Project	IEEE 802.16 Broadband Wireless Access Working Group < http://ieee802.org/16 >	
Title	Proposal for a new PDU concatenation scheme to facilitate MAC PDU separation under error conditions	
Date Submitted	2004-03-12	
Source(s)	<p>Sunny Chang, Bonggee Song, Taein Hyon, Yunsang Park</p> <p>Samsung Electronics 416, Maetan-3dong, Paldal-gu Suwon-si, Gyeonggi-do Korea</p>	<p>Voice: [82-31-279-5286] Fax: [82-31-279-5515] sunny94@samsung.com, bonggee.song@samsung.com, taein.hyon@samsung.com, yunsang.park@samsung.com</p>
Re:	Propose to IEEE 802.16 d or e ad-hoc group	
Abstract	This contribution proposes a new PDU concatenation scheme for enhanced PDU separation in IEEE 802.16d/D3-2004.	
Purpose	Discuss and adopt enhanced feature of 802.16d/D3.	
Notice	This document has been prepared to assist IEEE 802.16. It is offered as a basis for discussion and is not binding on the contributing individual(s) or organization(s). The material in this document is subject to change in form and content after further study. The contributor(s) reserve(s) the right to add, amend or withdraw material contained herein.

Proposal for a new PDU concatenation scheme to facilitate MAC PDU separation under error

Figure 1 MAC PDU separation algorithm based on IEEE802.16d/D3

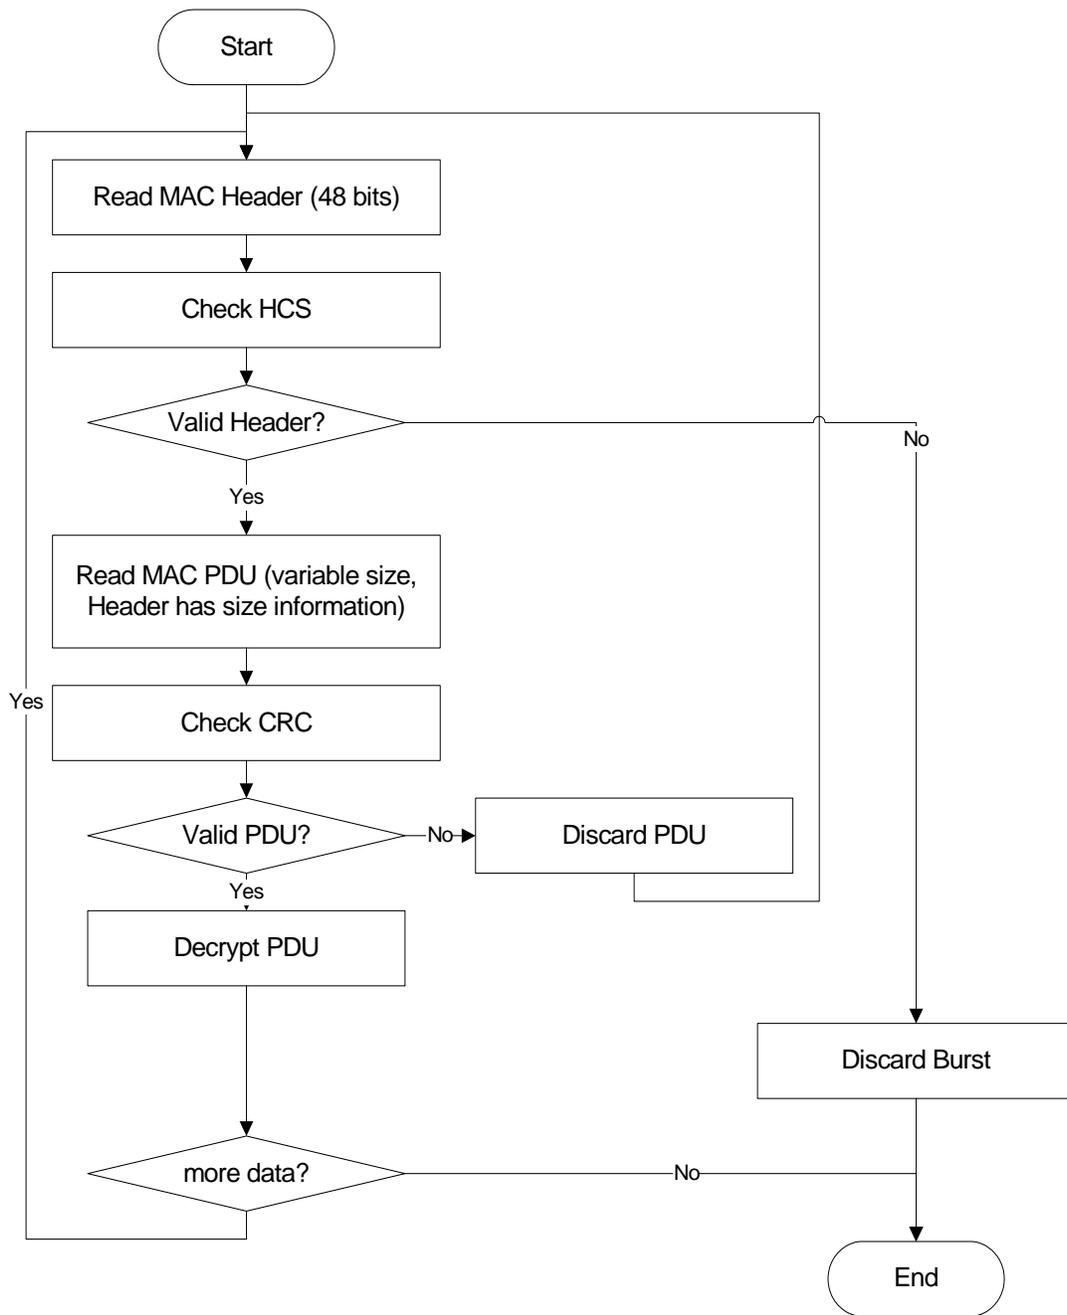
Figure 1 describes the sequence.

In this scheme, the receiver must obtain the size information for the previous PDUs to correctly determine the starting point of the following MAC PDU. Therefore, if there is an HCS error in any of the previous MAC headers, the following PDUs cannot be separated and needs to be discarded.

Figure 2 MAC PDU separation algorithm based on the new proposal

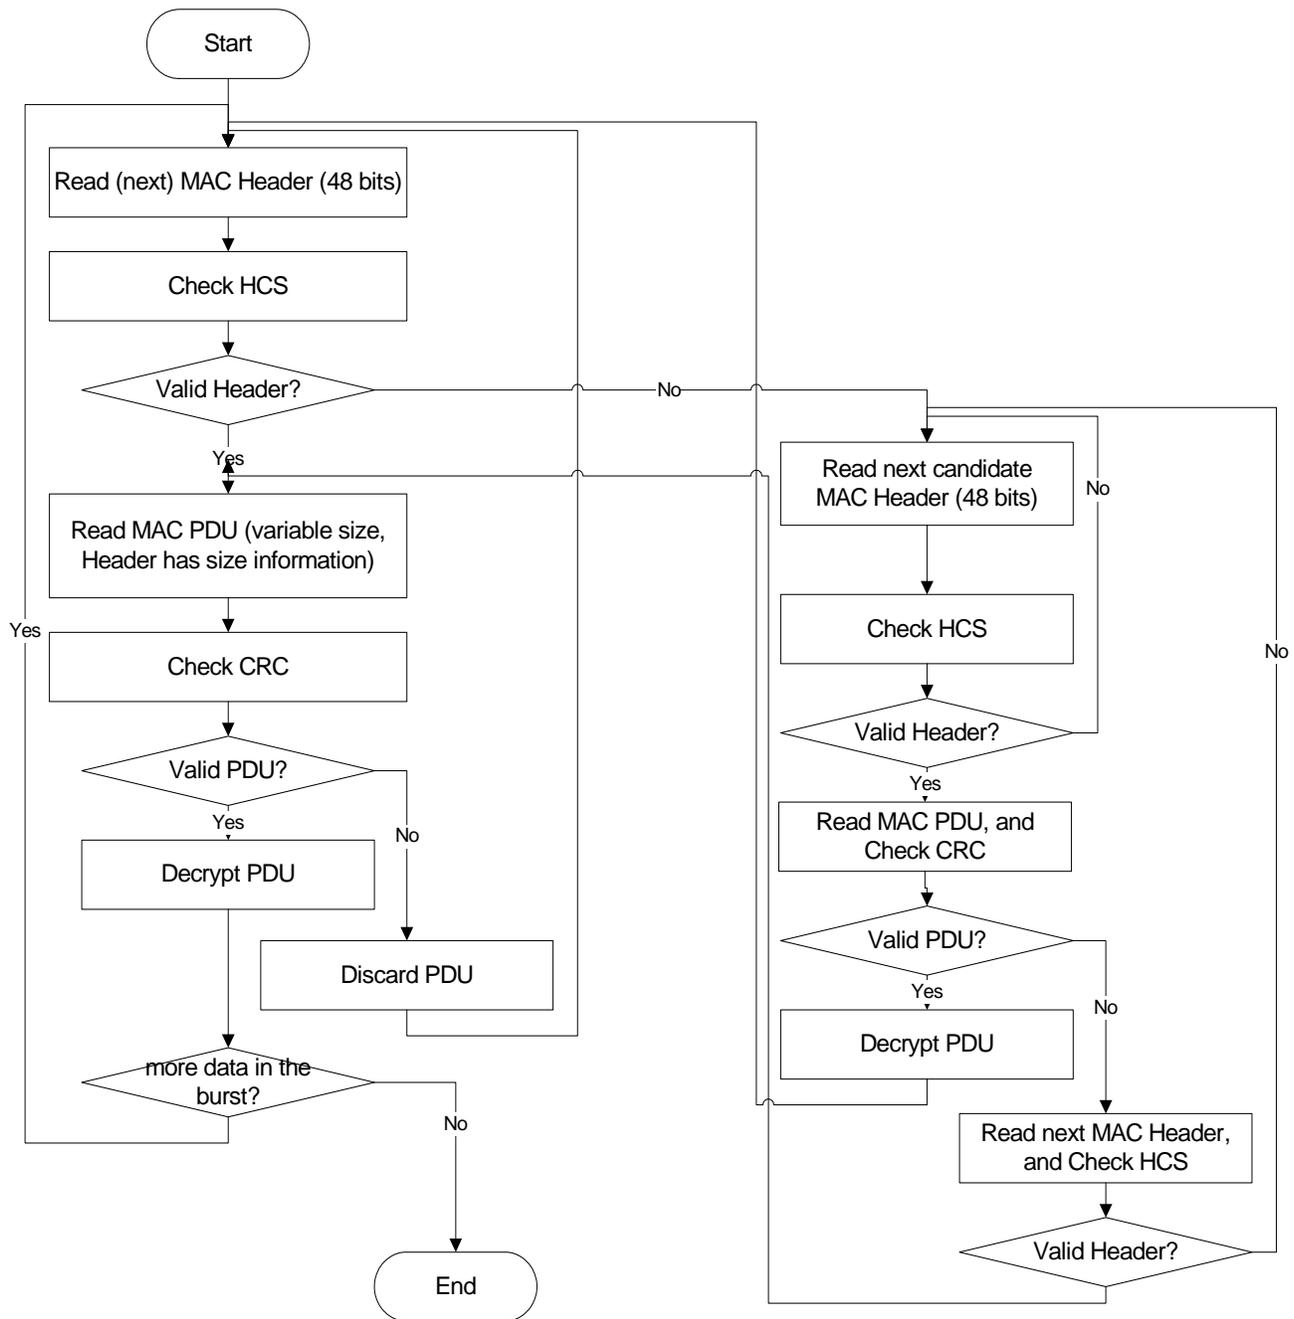
Unlike the current PDU separation scheme, the new scheme discards only the erroneous PDUs and continues the PDU separation by finding the starting point of the next PDU header. To accomplish this, it is essential to have a more comprehensive MAC header search mechanism for an arbitrary number of concatenated MAC PDUs. This section shows an example where the following MAC header is found using HCS and CRC for the case where the previous MAC header was in error.

- 1) If the MAC Header isn't valid, reads the first 48bit data that may be a MAC header and checks its validity using HCS.
- 2) If the 48 bit data is deemed validity by passing the HCS check, then the size information of the PDU is extracted from the length field. Otherwise, goes back to step 1)
- 3) Reads the current MAC PDU using the size information and checks the validity of the data using CRC. If the header is a bandwidth request header, this step is not necessary and will be skipped.
- 4) Reads the next 48 bit data and checks the validity of the MAC header using HCS.
- 5) If either the current PDU in step 3) or the next MAC header in step 4) is valid, the MAC Header, which was found in step 2), is considered correct.
- 6) If neither of them is considered valid, repeats Step 1) ~ Step 5) until the next MAC header is found.

Figure 2 describes the sequences.

Figure 26-MAC PDU concatenation showing example CIDs

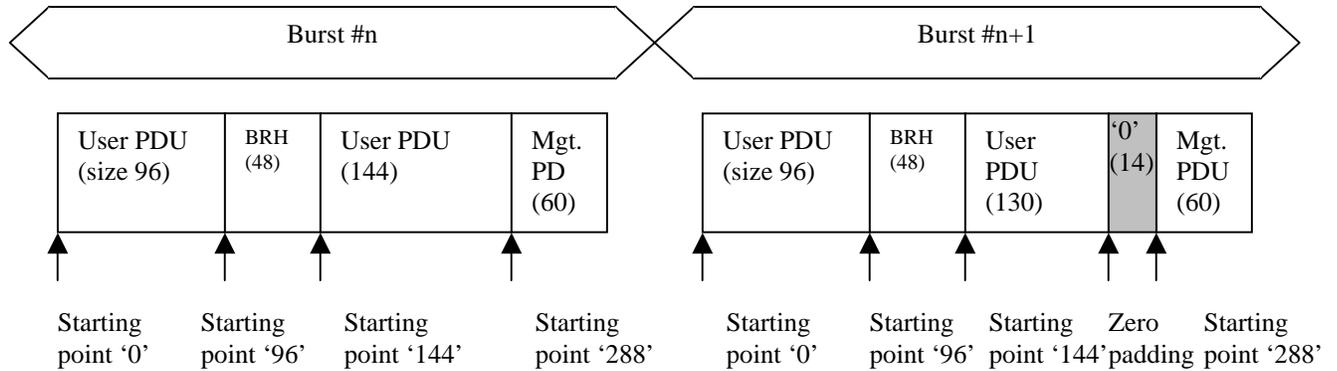
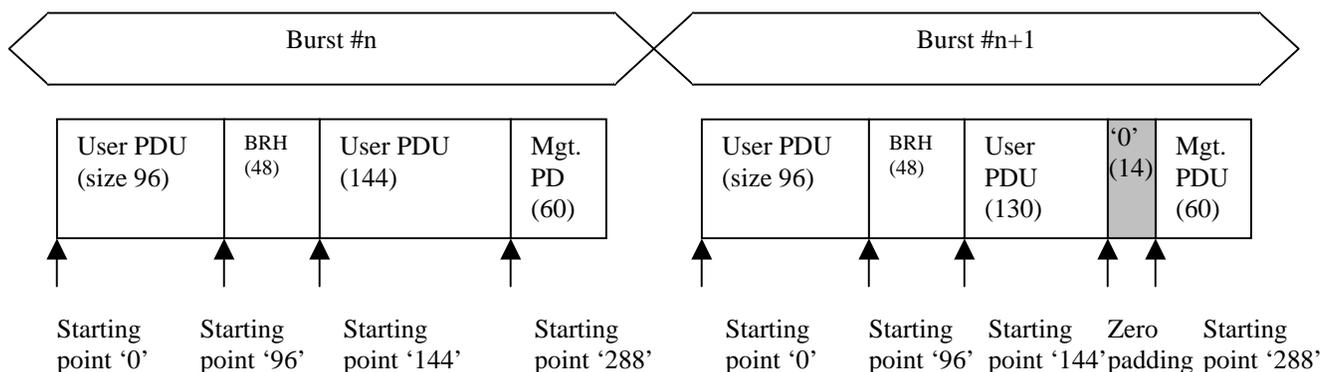
To resolve the issue with minimal processing complexity, we propose to restrict the MAC PDUs' starting point to be a multiple of 48bits in the burst. For the case where the connection does not allow fragmentation or packing, the size of the PDUs' may not be a multiple of 48 bits. In this case, zeroes padding is required from the end of the previous PDU to the start of the next PDU.

Figure 3 describes the proposed concatenation scheme.

Multiple MAC PDUs may be concatenated into a single transmission in either the uplink or downlink directions. When multiple MAC PDUs are concatenated into a single transmission, the starting position of each of the MAC PDUs have to be located at a multiple of 48bits position from the start of the burst. If necessary, zeros will be padded between the end of the previous PDU and the start of the next PDU. Figure 26 illustrates this concept for an uplink burst transmission. Since each MAC PDU is identified by a unique CID, the receiving MAC entity is able to present the MAC SDU (after reassembling the MAC SDU from one or more received MAC PDUs) to the correct instance of the MAC SAP. MAC Management messages, user data, and bandwidth request MAC PDUs may be concatenated into the same transmission.
